**SECTION 00 90 04
BIDDING AND CONTRACT REQUIREMENTS
ADDENDUM NUMBER 4**

Issued: October 12, 2023

Re: ADDENDUM NUMBER (4) TO THE BIDDING DOCUMENTS FOR

**McHenry County College
University Center at MCC**
Architect's Project Number: 22-050

SHEET NUMBER:
A7.10

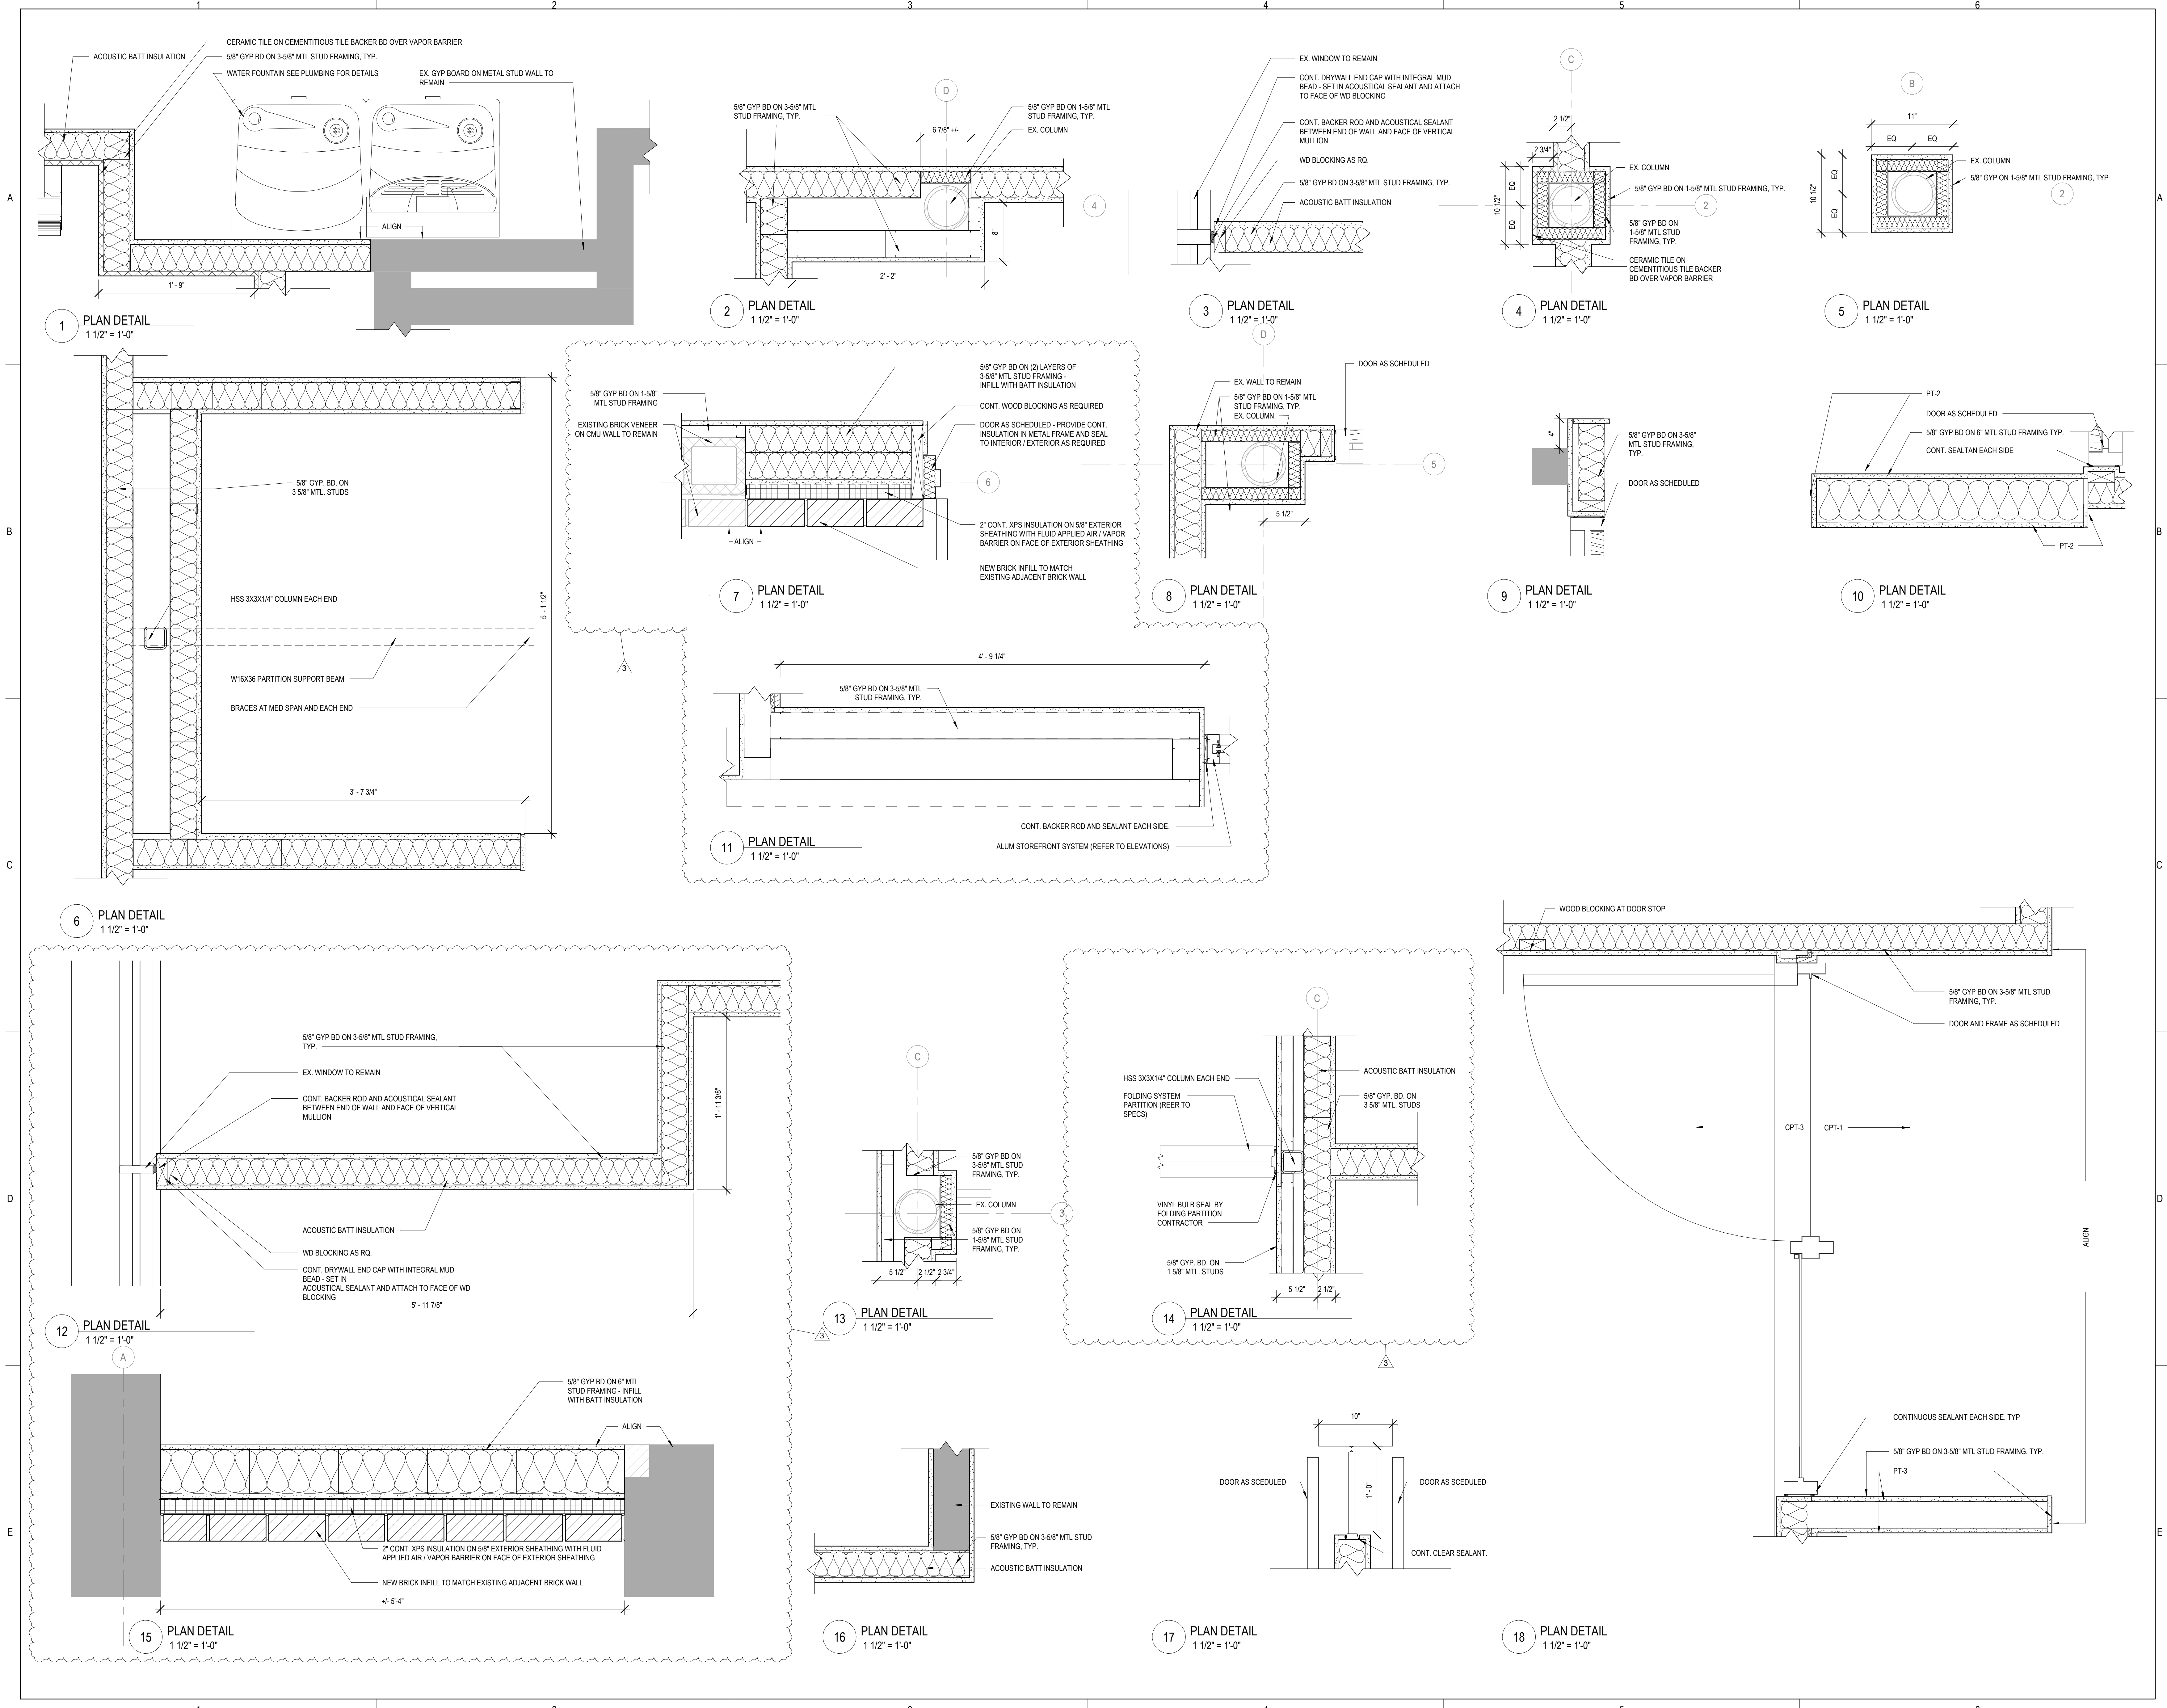
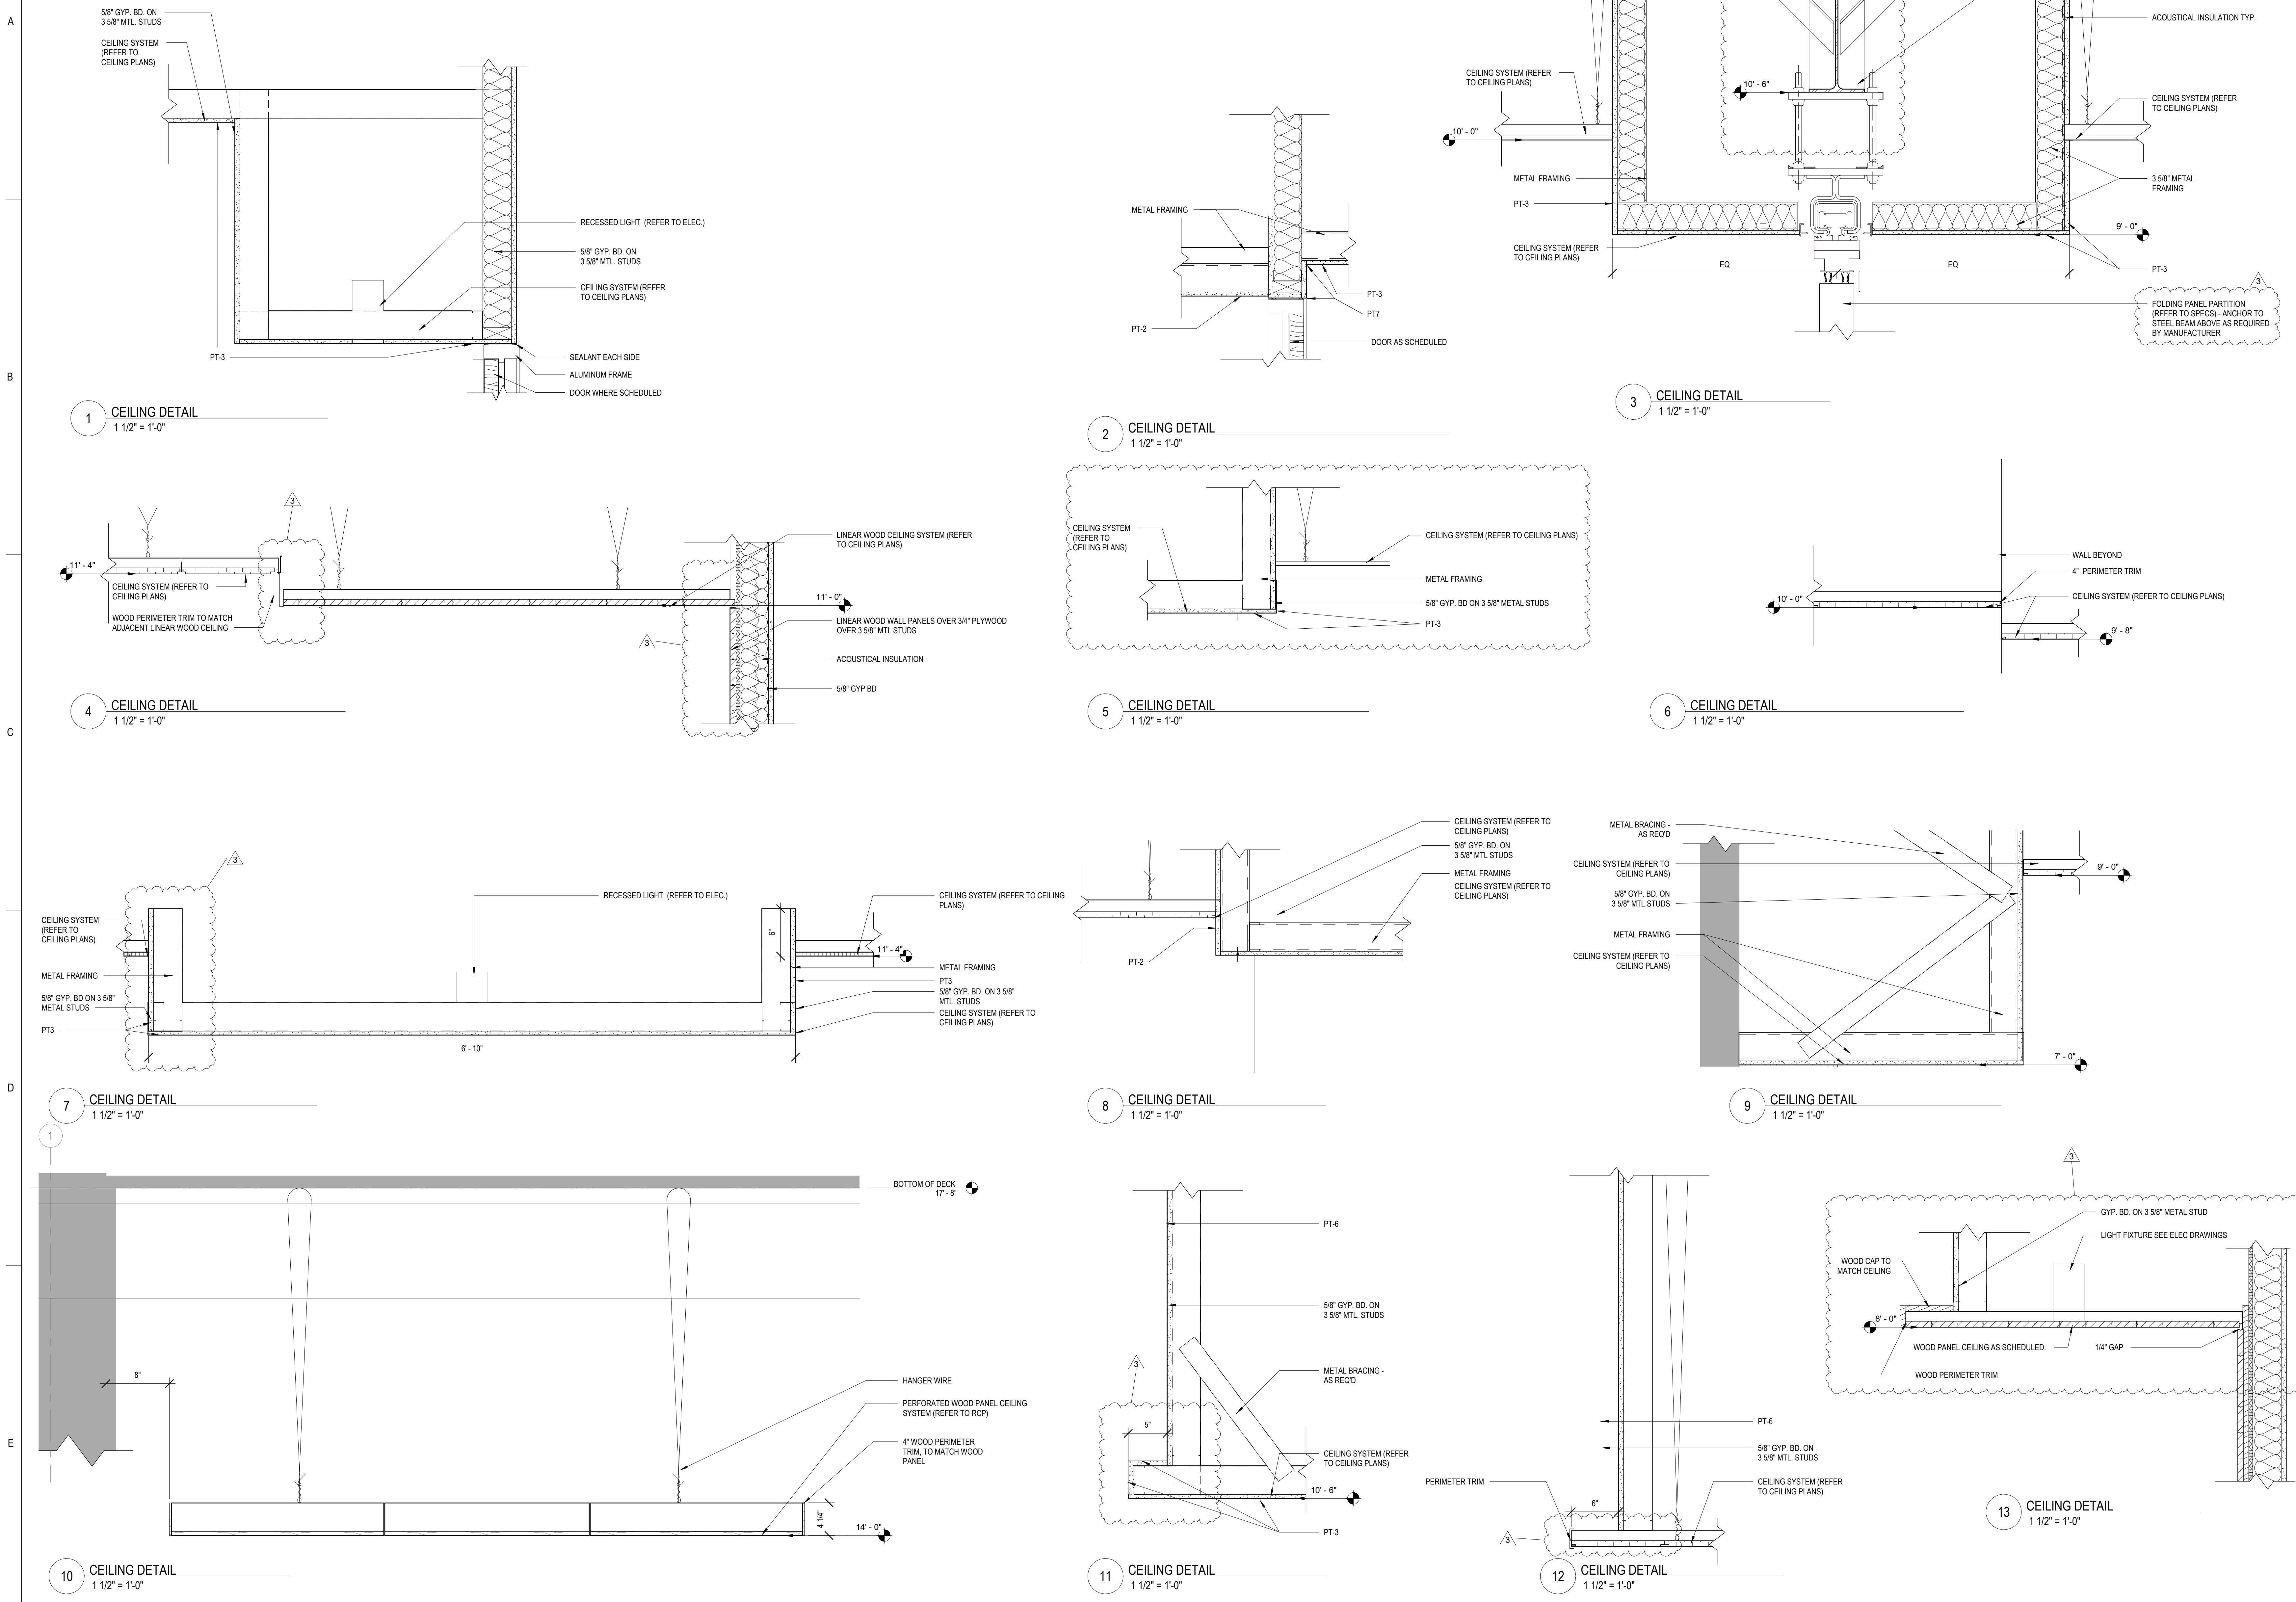
4. A2.51
 - A. **REVISE** enlarged RCP #1 as indicated.
5. A5.01
 - A. **REVISE** section 3 and 4 as indicated.
6. A7.10
 - A. **REVISE** details 7, 11, 12, 14, and 16 as indicated.
